Santa Ana River Wasteload Allocation Model Update

March 6, 2019

Responses to WEI Technical Question No. 1

Surface Water and Groundwater Interaction

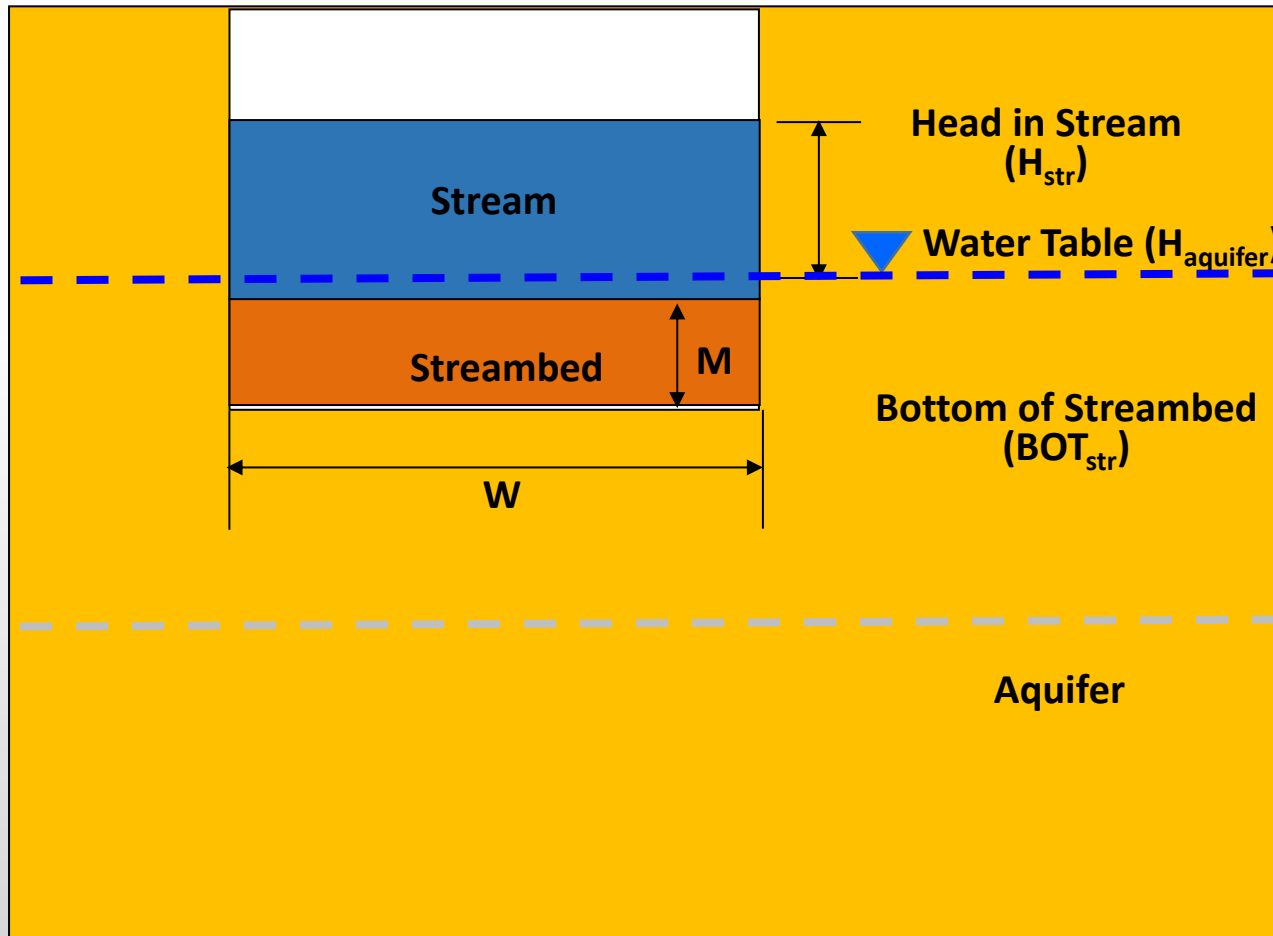
Comment	GEOSCIENCE Response
1. What does the real world look like? E.G. Characterize how surface water discharge and streambed infiltration vary along the axis of the Riverside-A GMZ for (1) wet weather conditions and (2) dry weather conditions.	Streambed percolation occurs upstream of the discharge point for the RIX Facility. Farther downstream, above MWD Crossing, there is a transition from a losing stream (where percolation occurs) to a gaining stream (where rising water occurs). This transition zone is dependent on groundwater elevations in the vicinity of the River, which changes based on hydrologic conditions. The amount of rising water is therefore also dependent on hydrology (i.e., wet vs. dry).

(1) Water Table Below Bottom of Streambed

$$BOT_{str} > H_{aquifer}$$

$$\text{Streambed Percolation} = C_{str} (H_{str} - BOT_{str})$$

Rising Water Approach 2017 WLAM HSPF

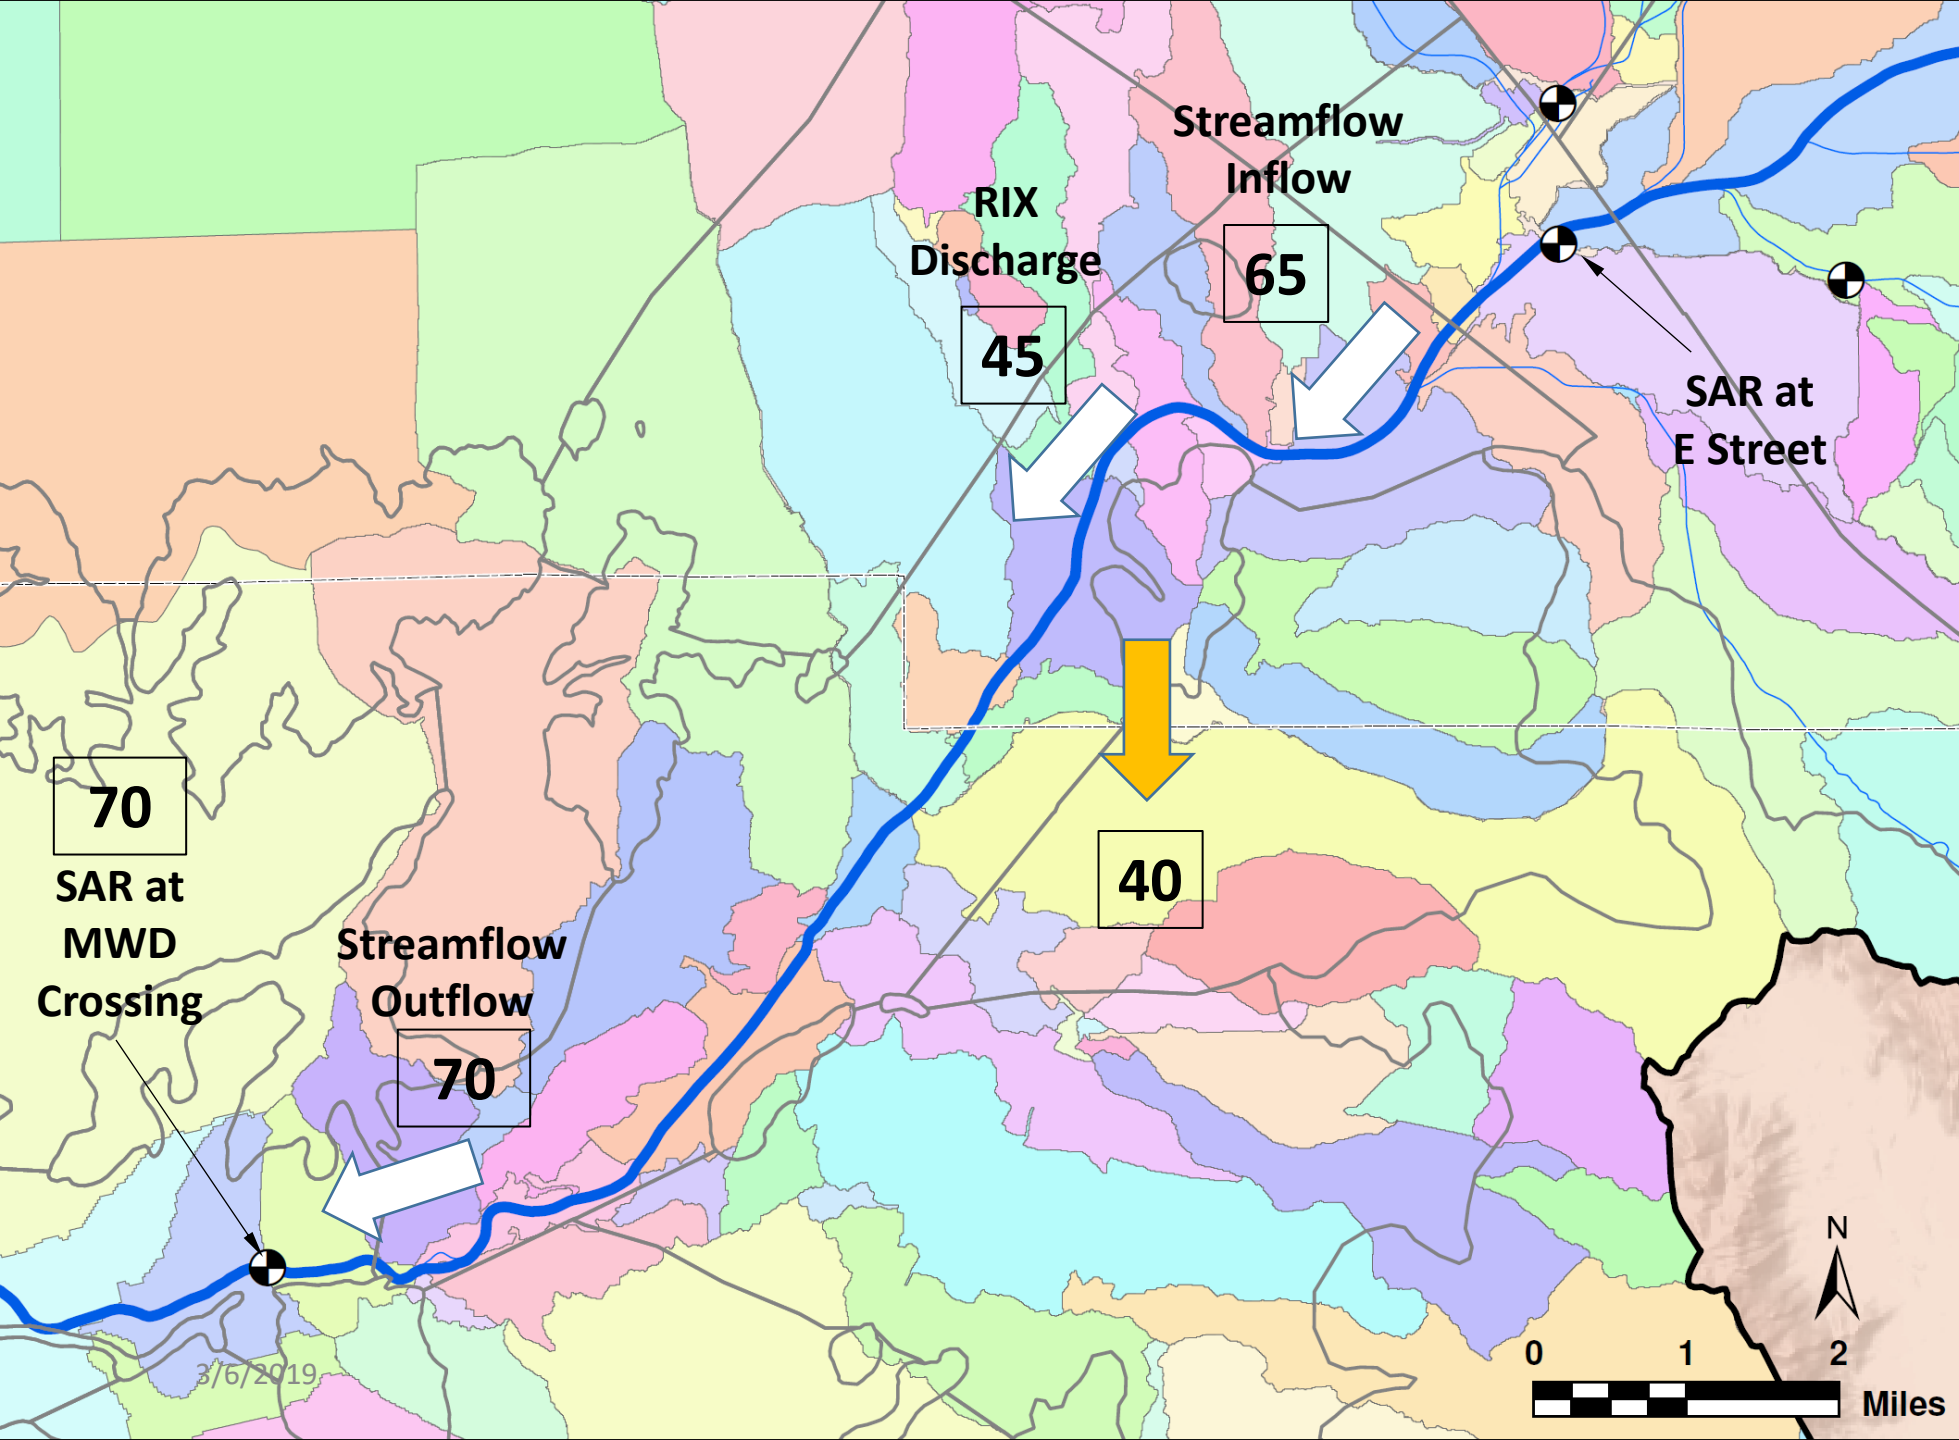
Comment	GEOSCIENCE Response
<p>2. How does each version of the WLAM represent the real world in Riverside A?</p>	<p>HSPF and other watershed models are limited in the fact that they are not able to simulate the interaction between groundwater and surface water. Percolation is calculated based on the flow in the river and the assigned streambed parameters. In reality, streambed percolation is dependent on groundwater level elevations; higher groundwater levels will cause a reduction in streambed percolation while the reversal of gradients (i.e., rising water) will effectively cause there to be no percolation.</p> <p>In order to account for rising water, the 2017 WLAM HSPF assumes zero percolation in the gaining reach (i.e., Reach 3 above MWD Crossing) and factors in assumed rising water during post-processing by adjusting model-calculated percolation upstream. Because the transition zone between the gaining and losing stream segments varies seasonally and annually, this approach relies on the overall average percolation for Reach 3 and 4 above MWD Crossing.</p>

- Streambed percolation is calculated by the model for Reach 4.
- No Percolation is assumed to occur in Reach 3 due to rising water.
- Model was calibrated so model-calculated flow at MWD Crossing matched observed flow from the MWD gage.

Riverside A GMZ and SAR Reaches 3 and 4

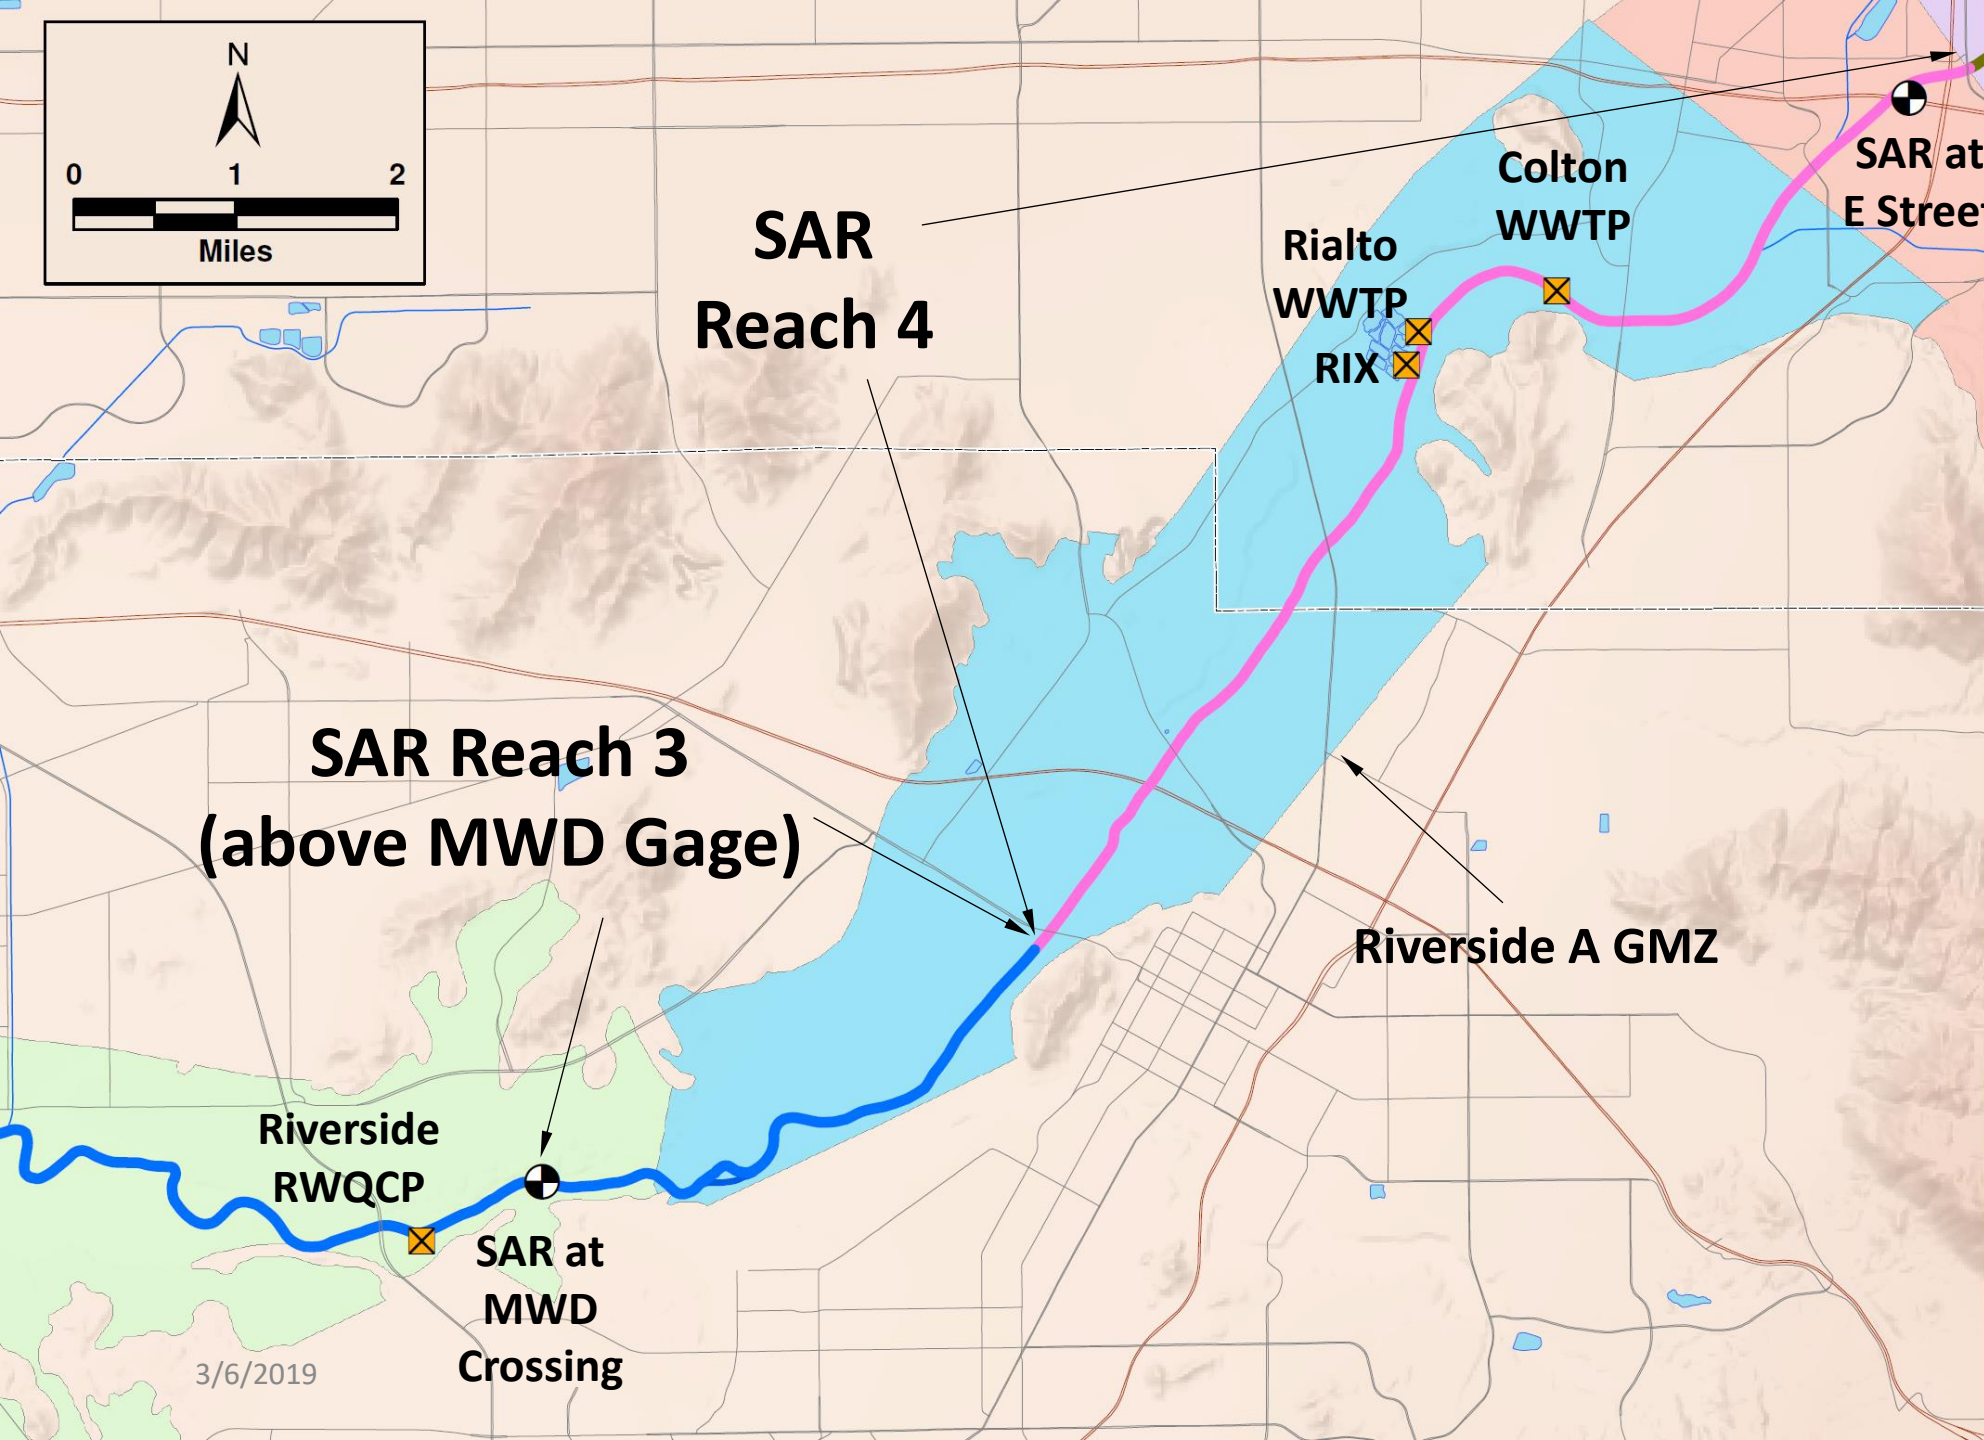
Comment	GEOSCIENCE Response
<p>1. What initial assumptions did the models make with respect to the permeability of streambed sediments in the upper half of Reach 3 (above the MWD gage)? How were these assumptions changed during the calibration process? Do the final calibrated values still align with our existing knowledge about the sediment characteristics in this area of the river?</p>	<p>The streambed conductivity of Reach 3 was assumed to be zero since SAR Reach 3 above the MWD gage is a gaining reach and receives rising water (if rising water is occurring, percolation is effectively zero).</p> <p>This assumption was not changed during the model calibration process.</p> <p>This assumption for streambed sediment conductivity is not consistent with the sediment characteristics in this area. However, this assumption was chosen to overcome one of the limitations of watershed models, which are unable to simulate the interaction between streamflow and groundwater. Rising water volumes were determined outside of the watershed model based on results from the existing groundwater model and incorporated into the post-processing phase of the surface water calculations above the MWD gage.</p>

Annual Riverside Narrows Rising Water

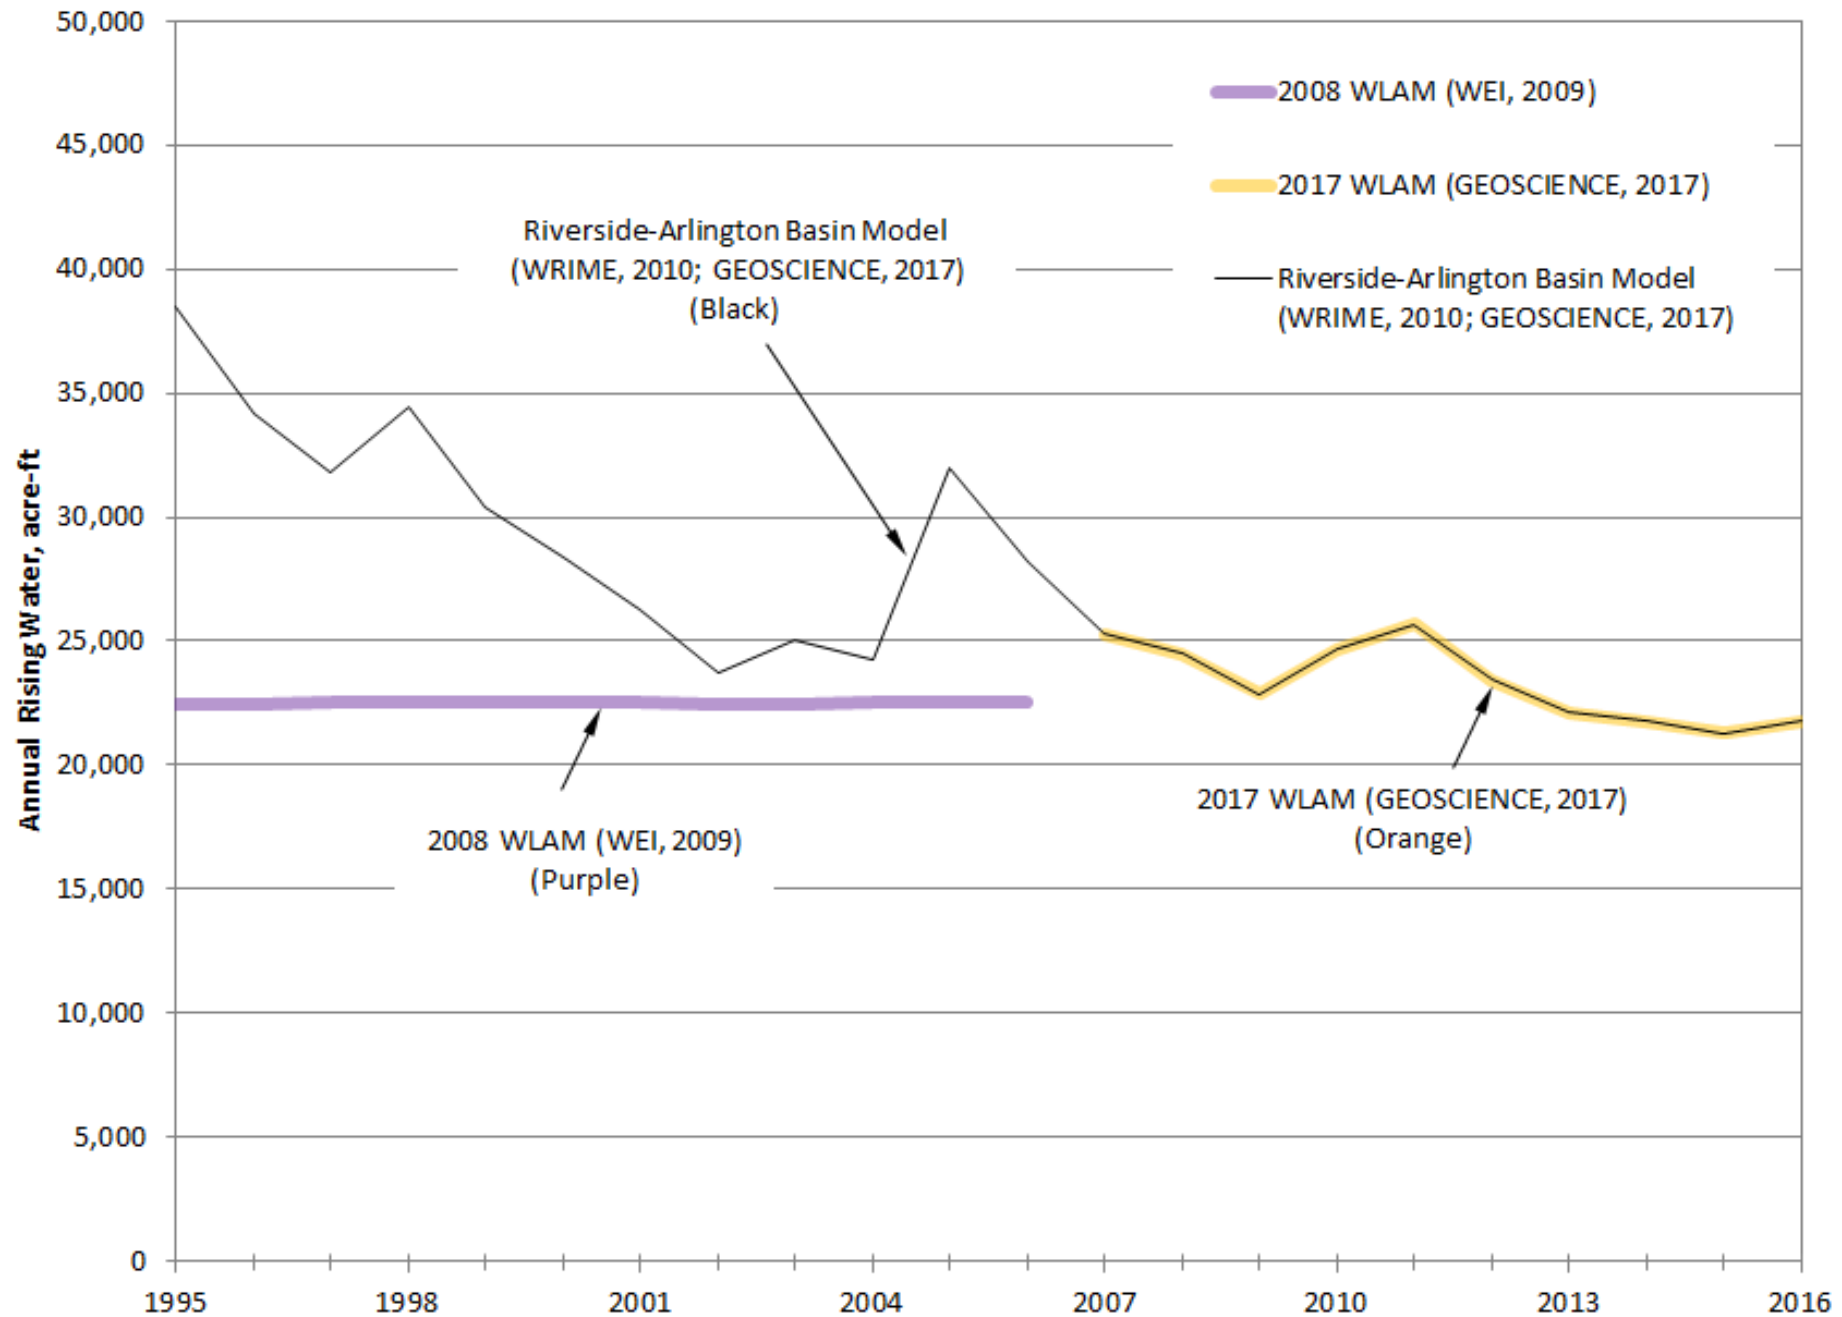
Comment	GEOSCIENCE Response
3. How was the amount of rising groundwater that occurs in upper half of Reach 3 estimated?	The amount of rising groundwater was estimated based on the results from the Riverside-Arlington Groundwater Model. These rising water values vary monthly based on the corresponding hydrological conditions and model-calculated groundwater levels.
